GROUP	MODEL
ELE	2022MY K5 (DL3a) w/o Smart Cruise
NUMBER	DATE
260	August 2022

TECHNICAL SERVICE BULLETIN

SUBJECT: **SERVICE ACTION: STEERING WHEEL REPLACEMENT FOR INCORRECT BUTTONS (SA505)**

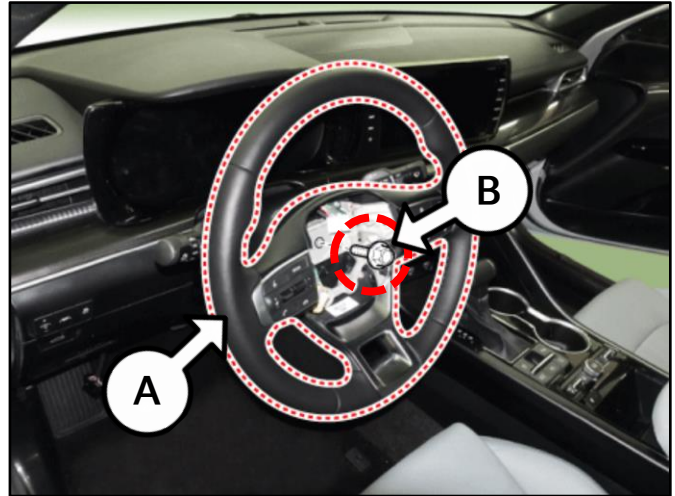
1. Replace the steering wheel (A) by referring to "Steering System → Steering Wheel → Repair procedures (Removal)" in the applicable Shop Manual on KGIS.

Tightening torque for Steering Wheel
Lock Bolt (B):
28.9 - 36.2 lb.ft (39.2 - 49.0 N.m)

The steering wheel lock bolt (B)
CANNOT be reused. Install a new bolt.
